AP63456 EGR Valve Replacement Instructions

All 6.4 L Power Stroke engines built after 11/24/2008 are equipped with an EGR valve that is no longer water cooled. Figure 1 shows an early style EGR valve that incorporates the cooling circuit and figure 2 shows the new, updated style EGR valve with no cooling circuit. All AP63456 EGR valves are the new style with no coolant line connections and are to be used on all 6.4 L models.

Figure 1
(Built before 11/24/2008)

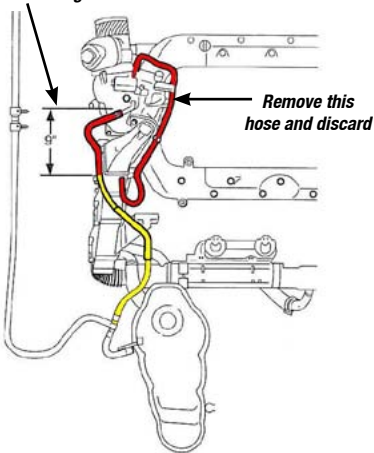
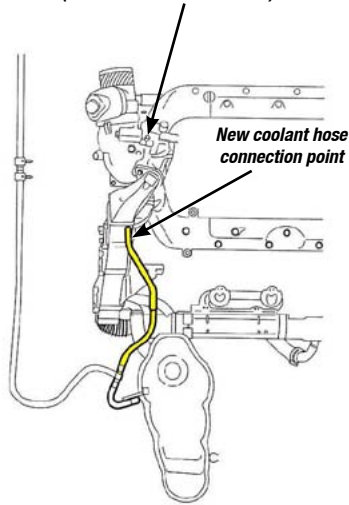
Remove 9 inches from this hose and relocate as shown in Figure 2

After installation of the new EGR valve, remove 9 inches from the coolant line that originally fed the EGR valve as shown in figure 1. Next relocate the cut end of the hose to the location shown in figure 2. The remaining hose shown in figure 1 should be removed and discarded.
